REQUEST

Current Zoning: NS PED (neighborhood services, pedestrian overlay)
Proposed Zoning: MUDD(O) PED (mixed use development, optional, pedestrian overlay)

SUMMARY OF PETITION

PLANNING STAFF REVIEW

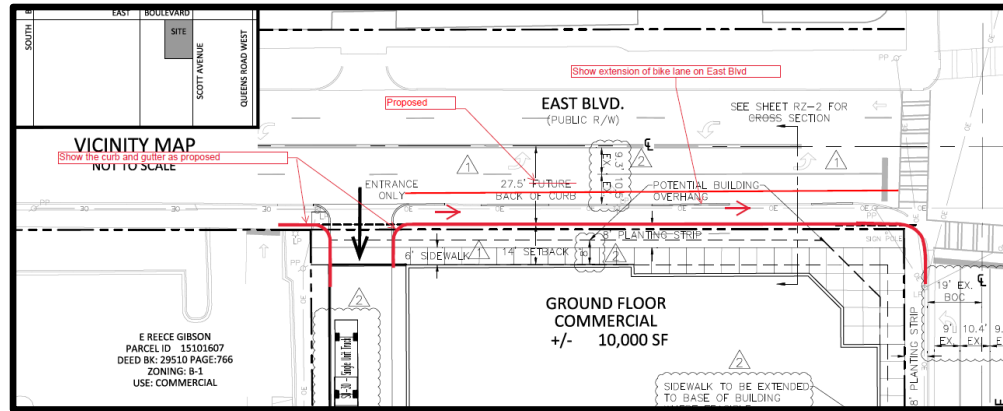
1. The proposed zoning district has a setback measured from back of the existing or proposed future curb.
 - a. Scott Avenue: The future location of curb and gutter is in its existing location.
 - b. East Boulevard: The proposed curblineline and setback need to be revised from what is shown on the site plan.

6. **Technical Clarification based on revised site plan (11/24/2020)** The petitioner shall revise the site plan to show the proposed curb and gutter at its future location. The site plan should also reflect the extension of bike lane on the south side of East Blvd, per Charlotte BIKES.
